# ***Value Engineering Study Report***

## ***SR 8/US 78 at Mann Road/Mason Creek Road and at Post Road Intersection Improvements, Douglas County CSSFT-0008-00(375), PI No. 0008375***

***February 2012***

Subject: Final Value Engineering Study Report  
***SR 8/US 78 at Mann Road/Mason Creek Road and at Post Road  
Intersection Improvements, Douglas County, CSSFT-0008-00(375)  
PI No. 0008375***

Use more slope easements in lieu of permanent right-of-way

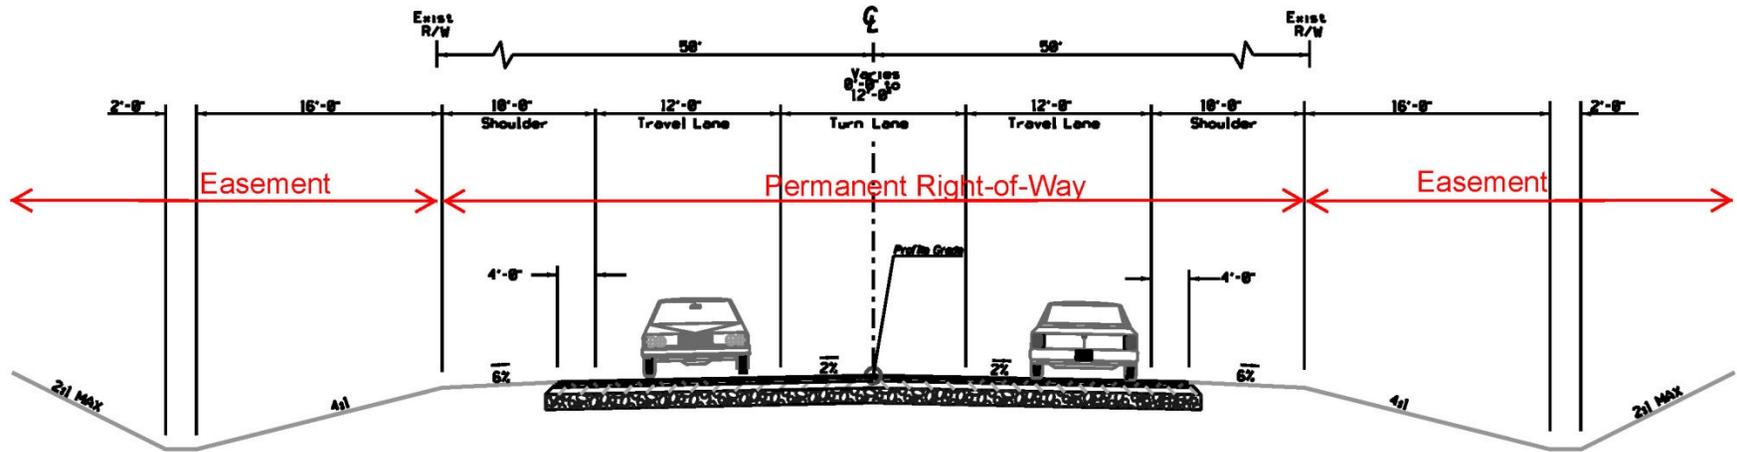
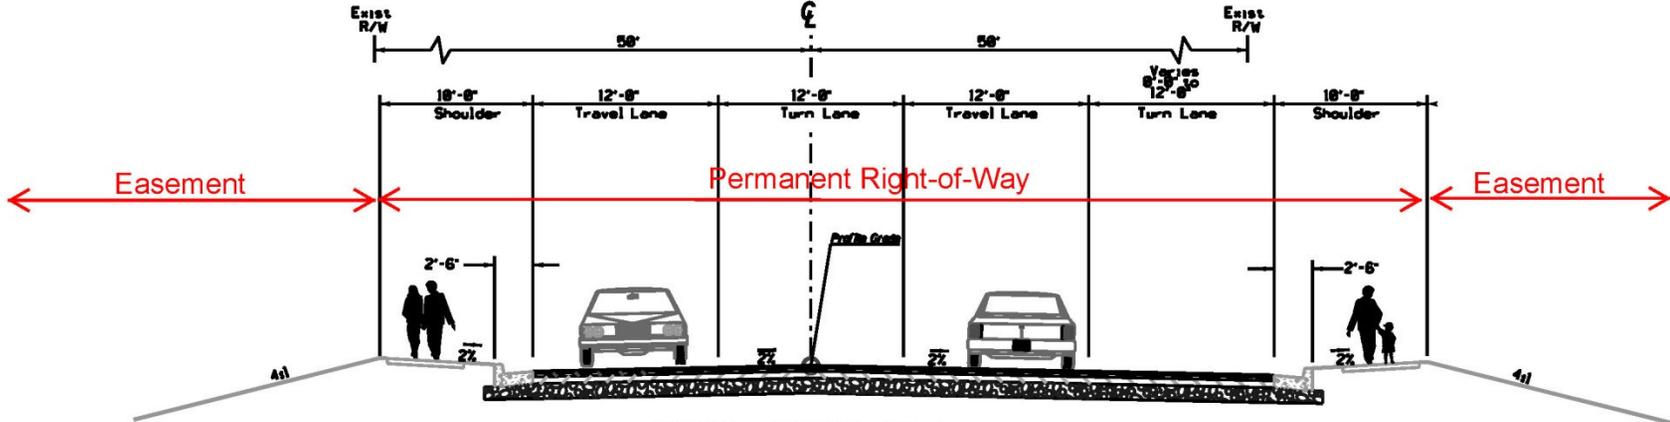
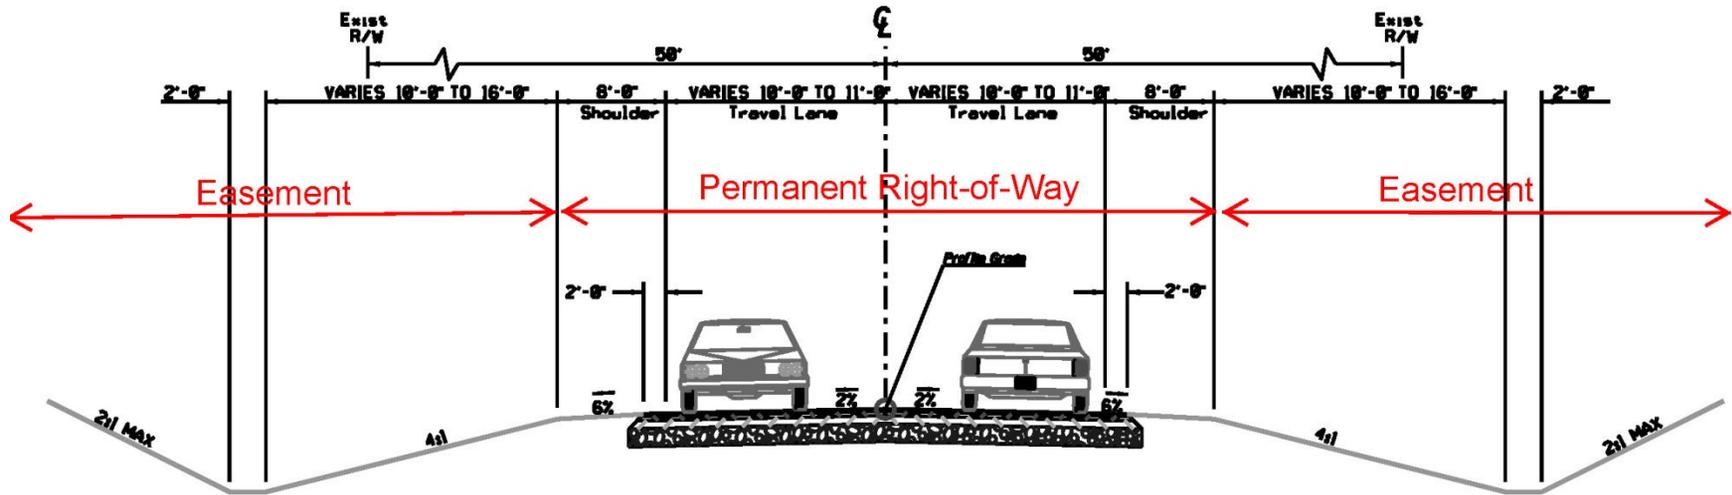
GDOT has accepted the use of easements on a number of recent projects as an effective way to control the overall cost of right-of-way. Full right-of-way purchase may be prudent at specific locations due to maintenance access issues, but oftentimes easements provide the equivalent function at approximately 60% of the cost of a full right-of-way purchase.

**Discussion:** The need and purpose of the project is to reduce crashes and provide improved operations at the area intersections. This can be accomplished with slopes and ditches included in easements instead of required right-of-way.

Use more slope easements in lieu of permanent right-of-way

**VE ALTERNATIVE S-1**

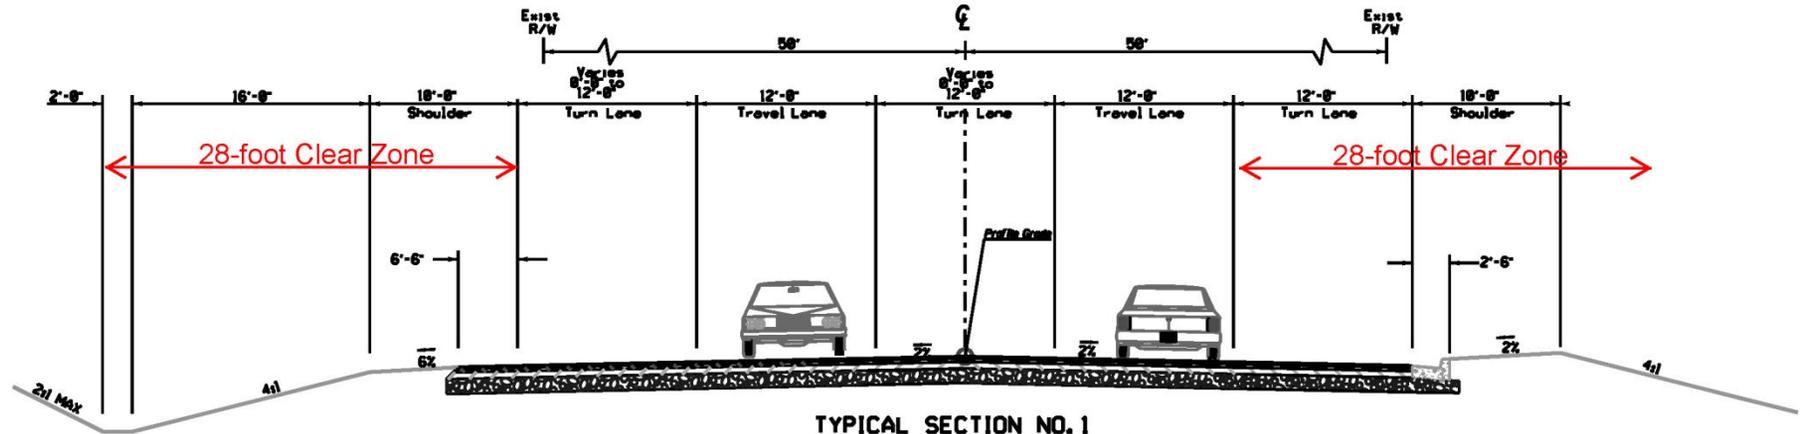
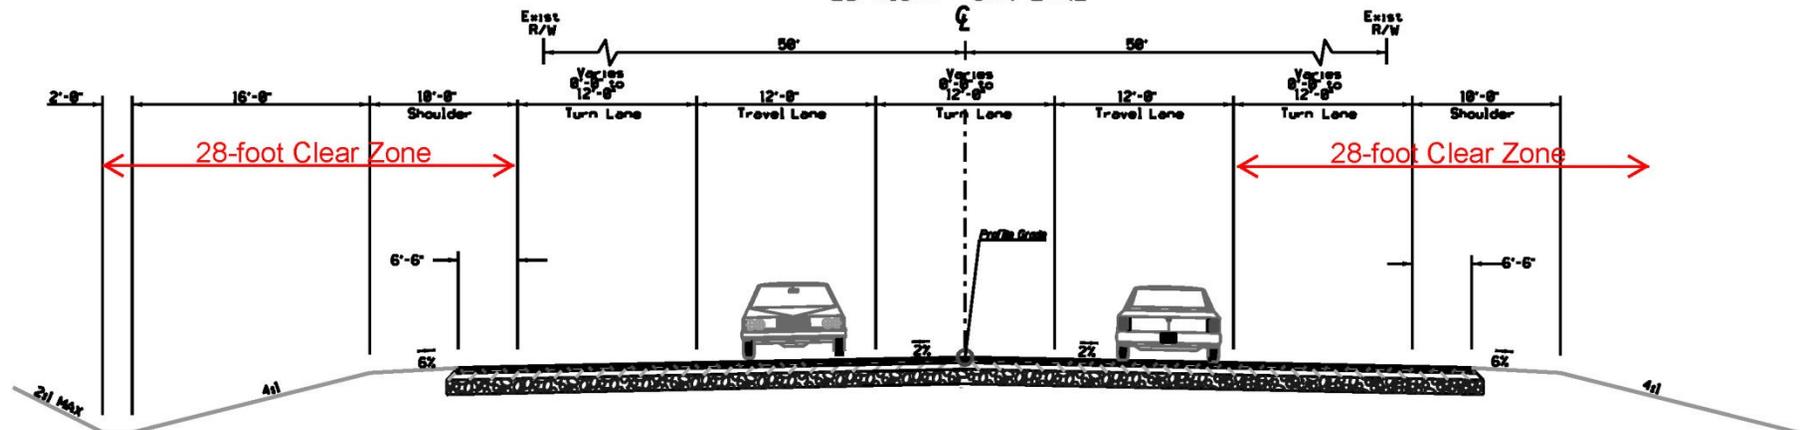
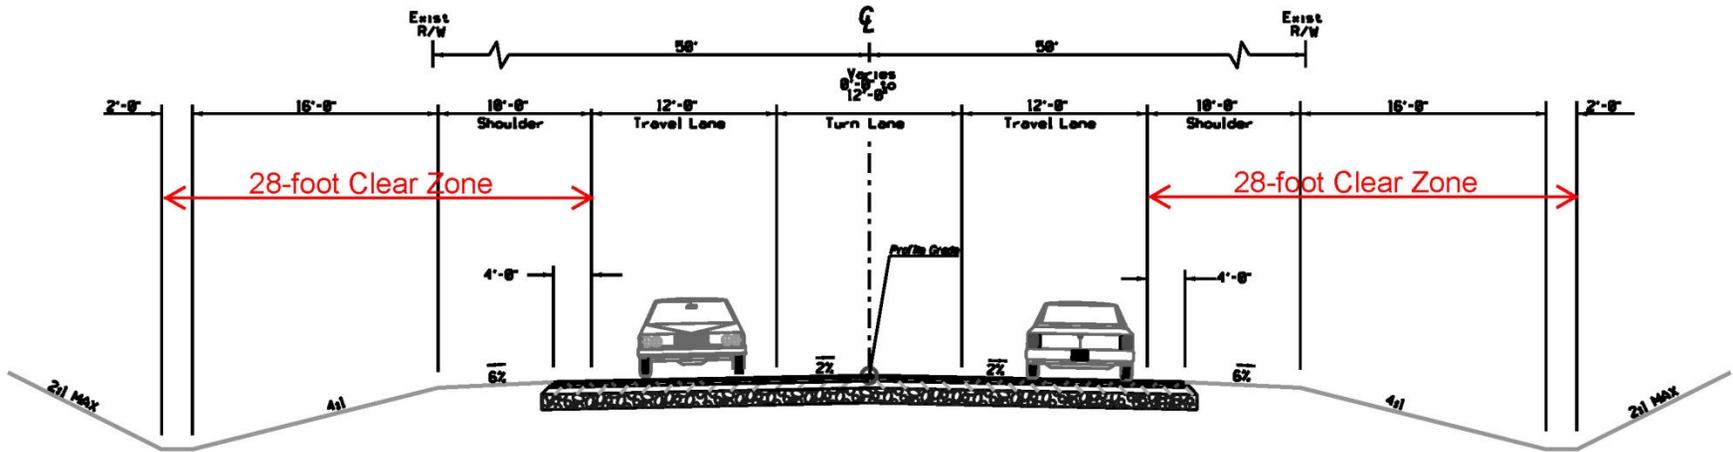
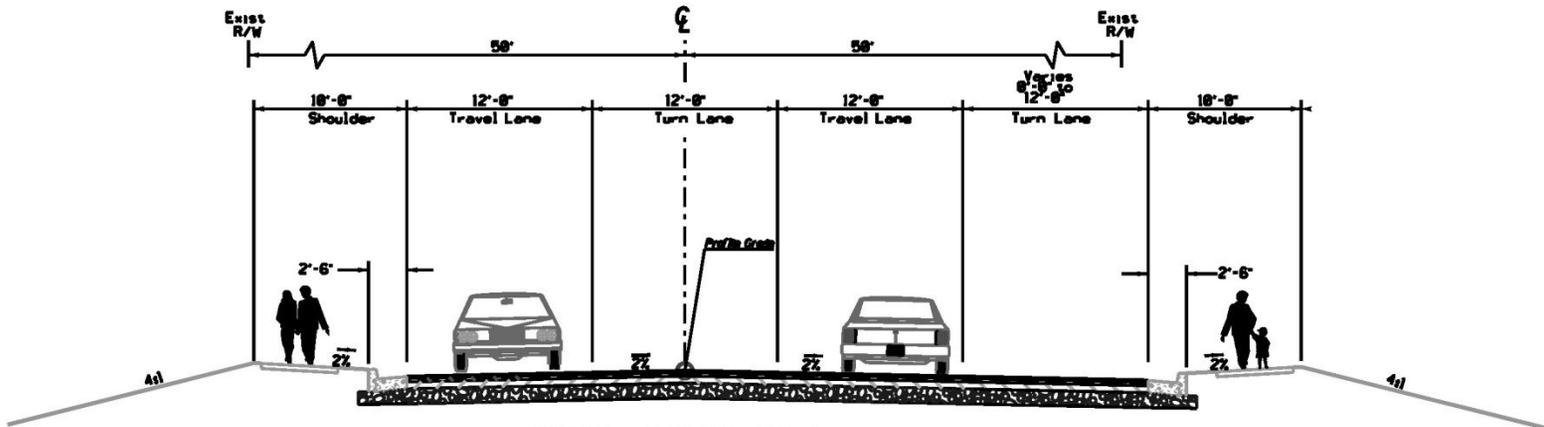
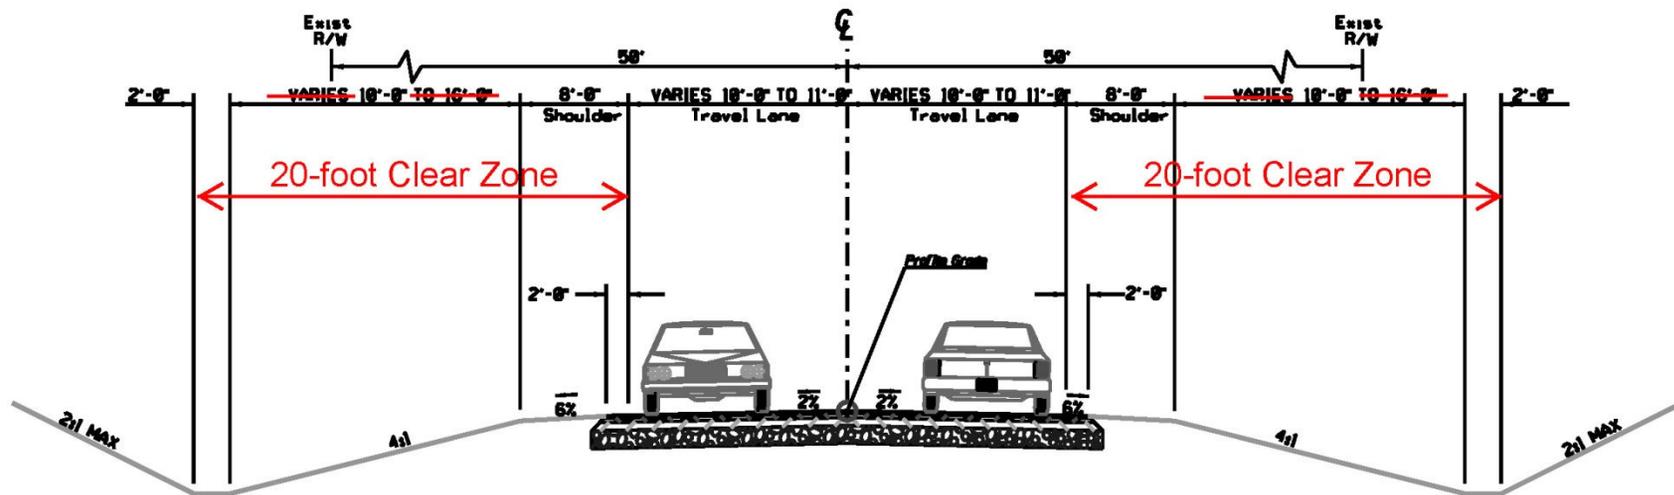
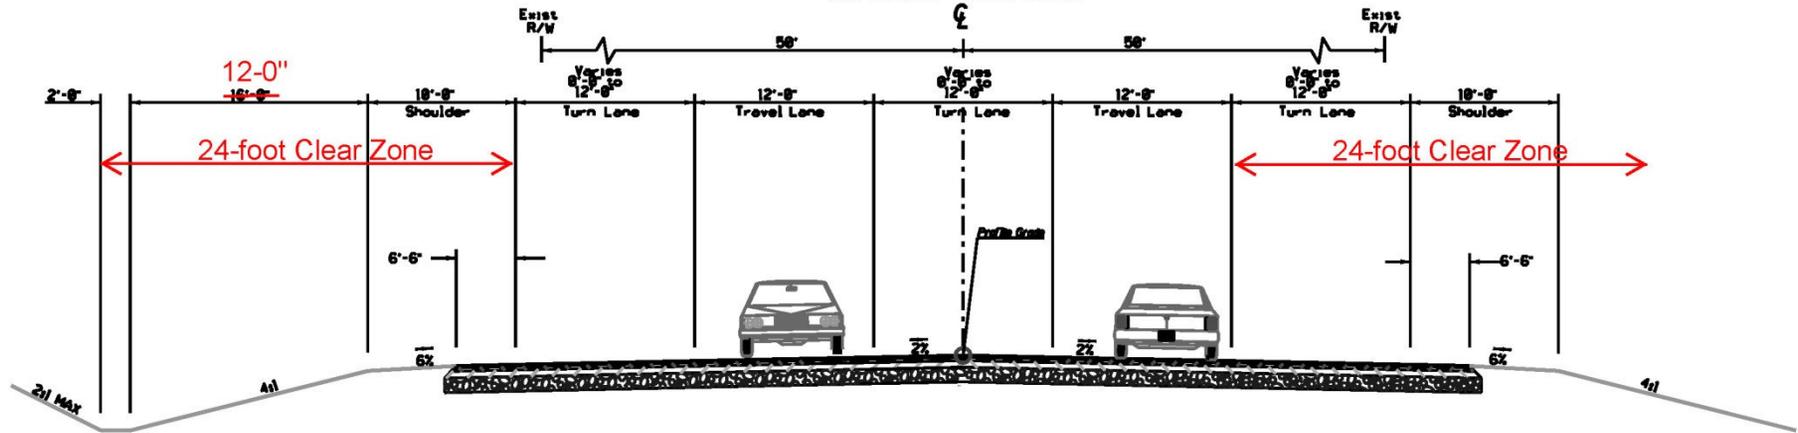
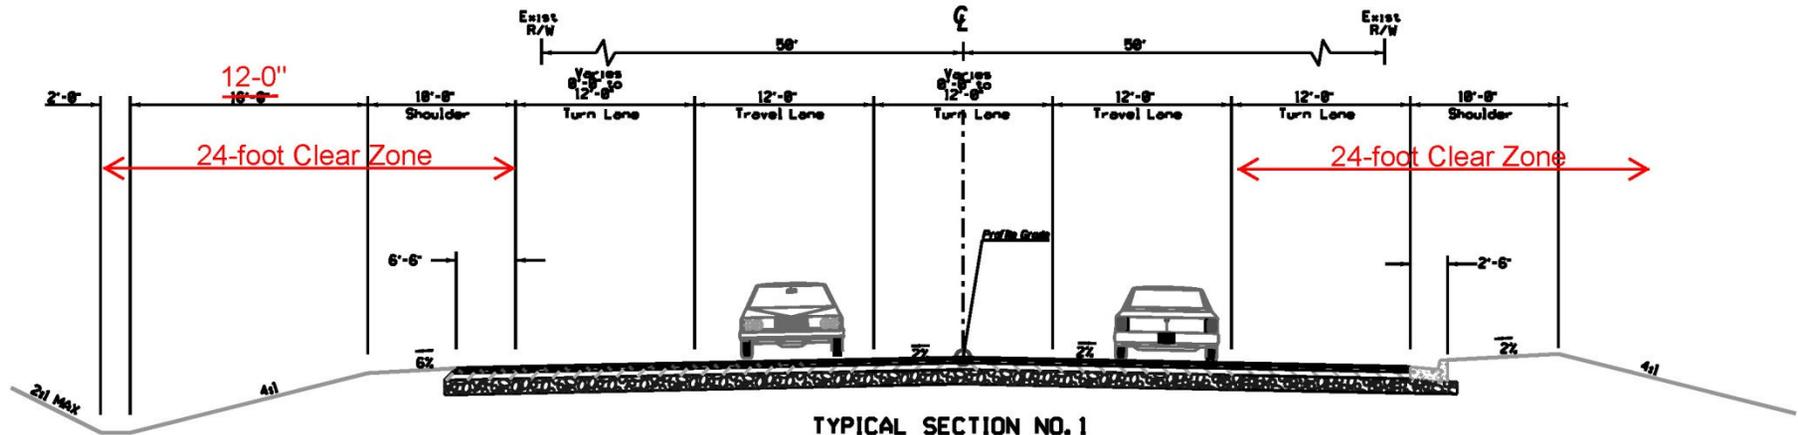
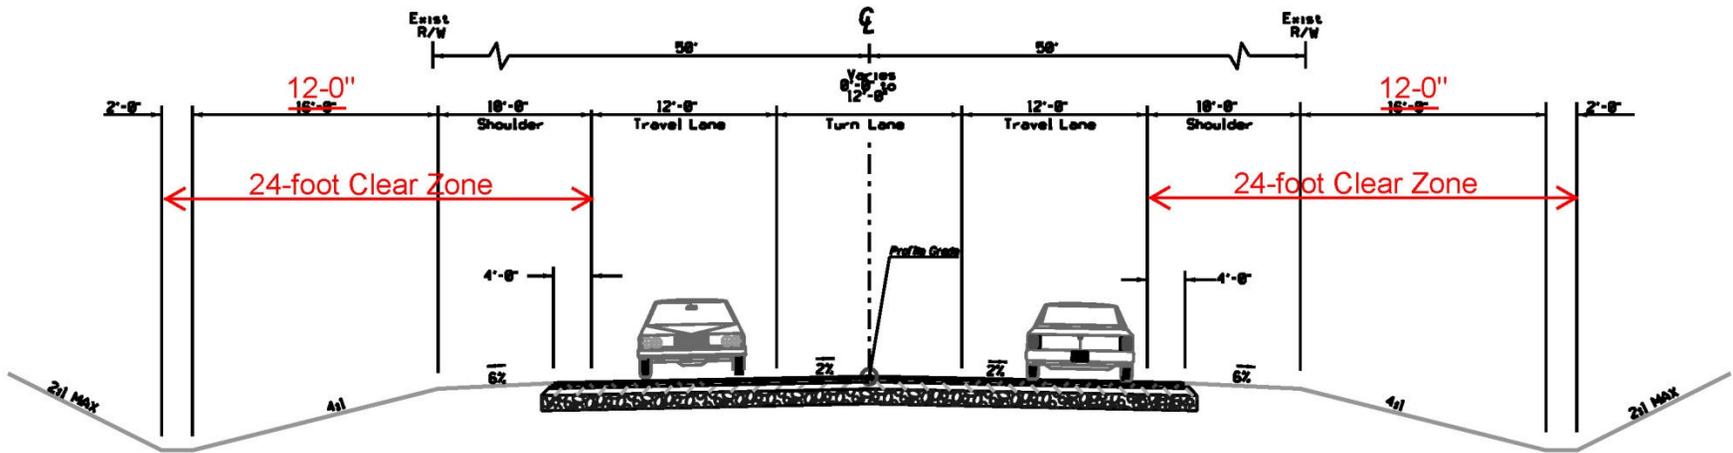
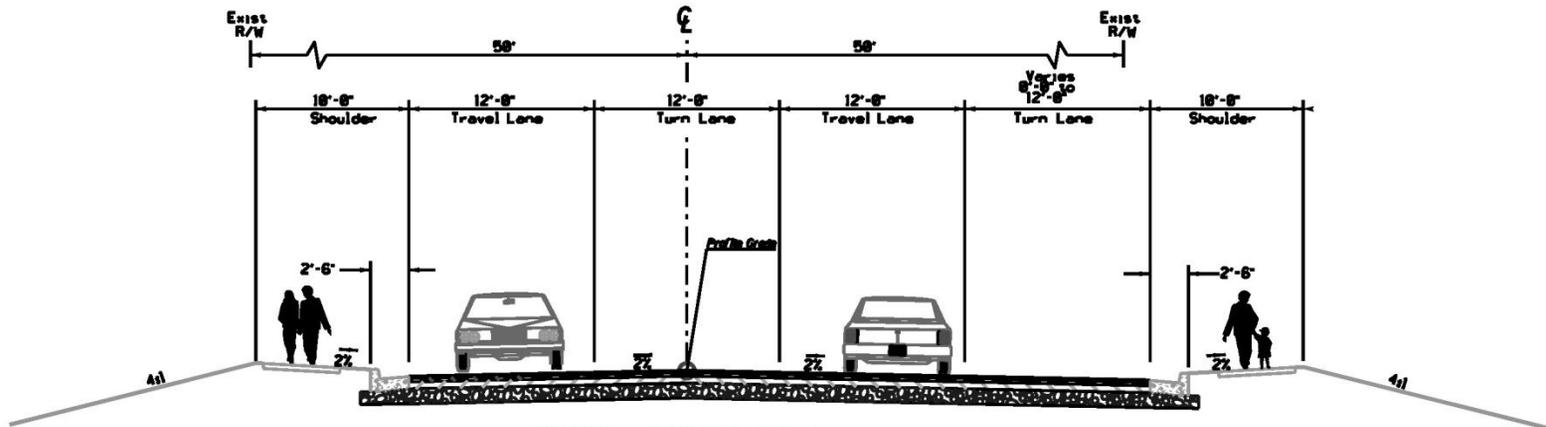
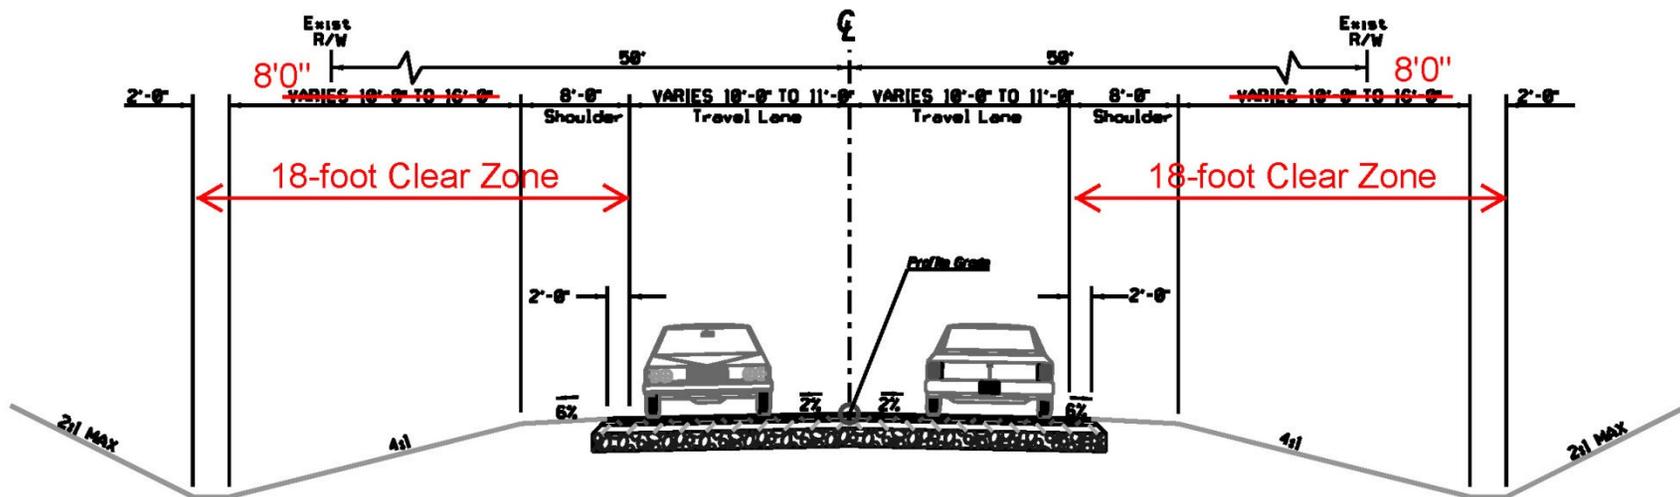
**Description of Alternative Concept:** Revise the clear zone widths to 24 feet for 45 mph arterial and 18 feet for 35 mph local in accordance with the GDOT Design Policy Manual Tables 6.4 and 6.6. This adjustment will result in the construction limits and required right-of-way acreage being reduced.

**Discussion:** There does not appear to be any existing site conditions to warrant clear zone width in addition to the standard widths prescribed for the project design speeds and roadway types.

Reduce the clear zone dimension to 24 feet and 18 feet for the 45 mph and 35 mph design sections, respectively
